# Metropolitan Planning Commission

Staff Reports

September 25, 2008

**2008S-147G-06**  
 Ellen's Subdivision  
 Map: 155-00 Parcel: 104  
 Bellevue Community Plan  
 Council District 35 – Bo Mitchell

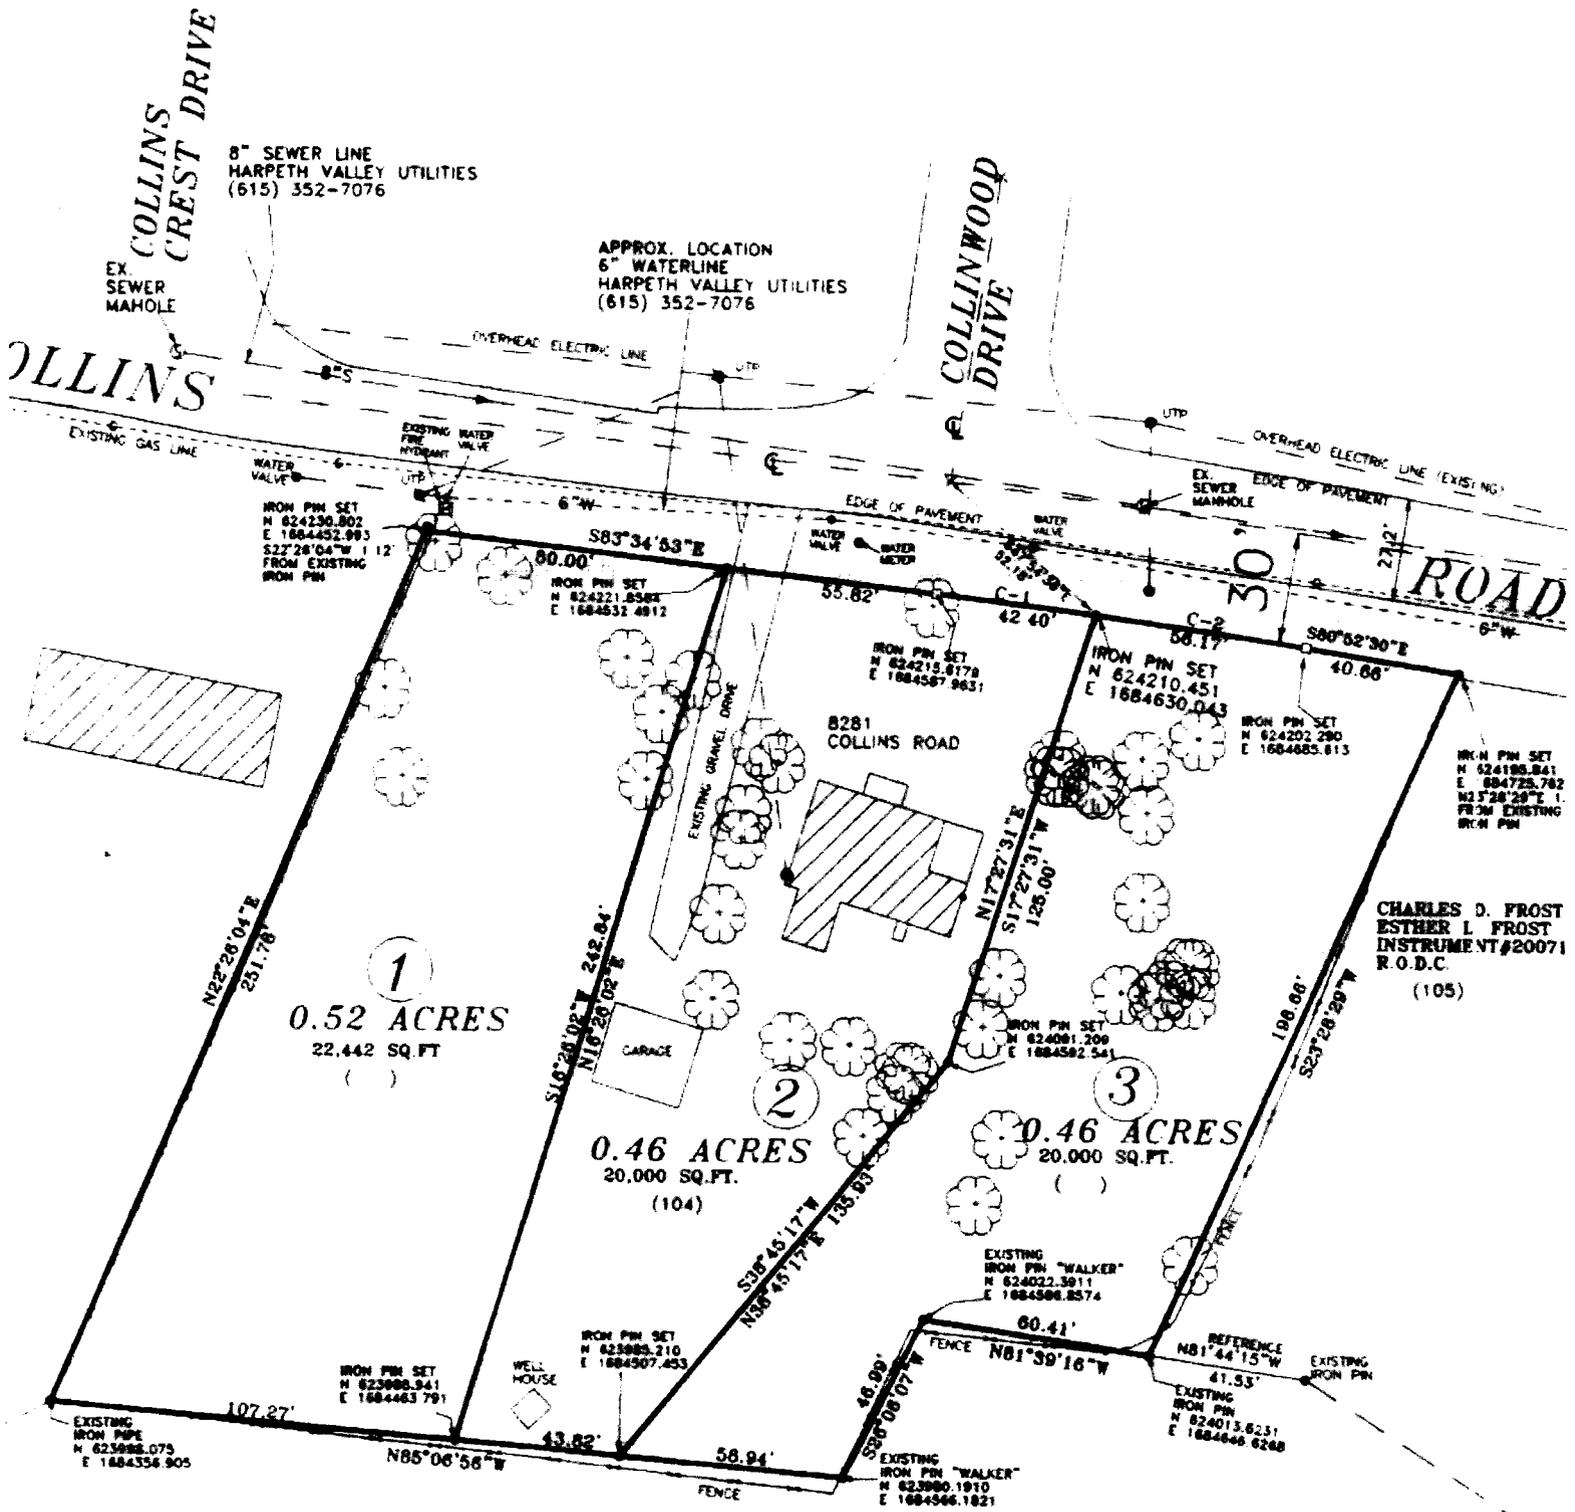
The Fire Marshal has requested that the applicant provide hydrant flow data for this property. To date, this information has not been provided.

One & two family final plat plans must show results from fire hydrant(s) flow test, performed within 6 months with a minimum of 1000 gpm @ 20 psi available at hydrants, for buildings up to 3600sq. ft. to be approved for fire hydrant flow requirements.

Staff recommends approval with the condition that the applicant provide fire hydrant flow data to the Fire Marshal.
